Our ref: STH20/00139/04
Contact: Andrew Lissenden 0418 962 703
Your ref: SSD-14394209

STATE SIGNIFICANT DEVELOPMENT 14394209 – NEW HIGH SCHOOL, ASSOCIATED INFRASTRUCTURE AND COMMUNITY CENTER IN BUNGENDORE – PUBLIC EXHIBITION OF ENVIRONMENTAL IMPACT STATEMENT

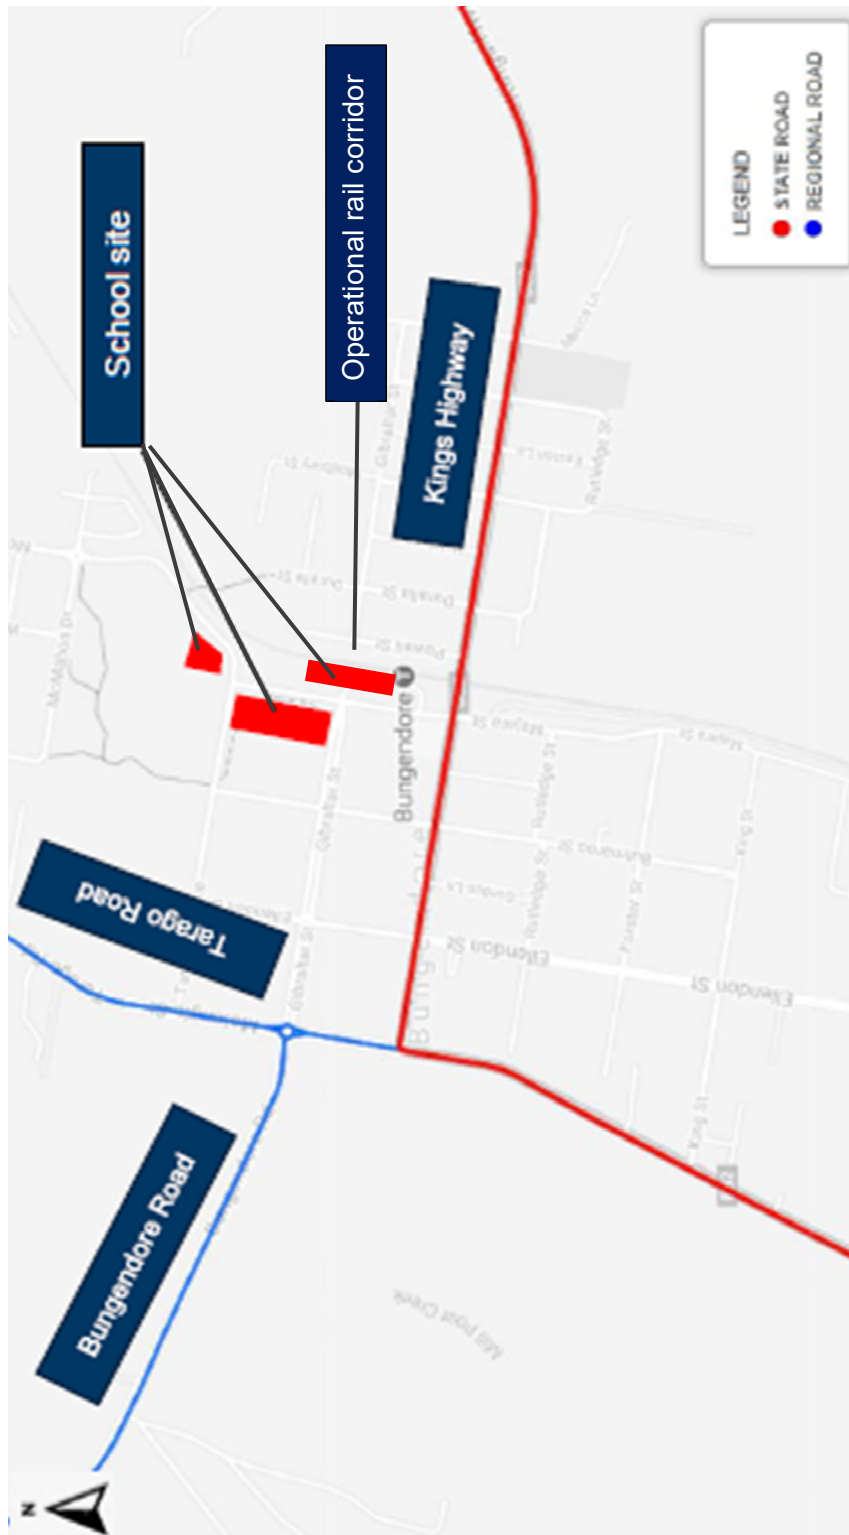
- the key state classified road is the Kings Highway/Malbon Street to which the development gains access via the local road network (refer to **Attachment 1**);
- the rail corridor located on Lot 4 DP 830878 (adjacent to the sites eastern boundary - refer to **Attachment 1**) forms part of the operational Tarago to Queanbeyan rail corridor;
- the SSD is seeking approval to construct a new high school that will accommodate 450 students and 41 operational staff with associated facilities (car parking, play areas, fencing, bus bay, kiss and ride facilities, etc). It also includes a community building containing a community library, Council shopfront and community health hub; and
- the impact of the proposed development on both the state road network and the adjacent rail corridor needs to be considered and adequately mitigated.
